Access Compliance Report Public Rights-of-Way (Curb Ramps)

Intersection ID: 10042362 Main Street: WRIGHT_AV Cross Street: DELANE_AV Location: SE

ADA ID: F9CC125BBB49 Ramp Type: Perp Initial Pass/Fail: Pass Overall Compliance: No Severity Score: 7.5

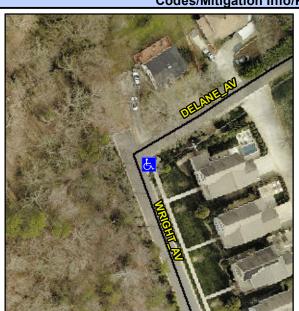
Possible Solutions:	
Remove & Replace Entire Ramp. Remove & Replace Gutter.	
Surveyor Notes:	
N/A	
PROW/ADA:	
Not Found, R304.2.1, R305.1.4, R305.2, R304.5.4
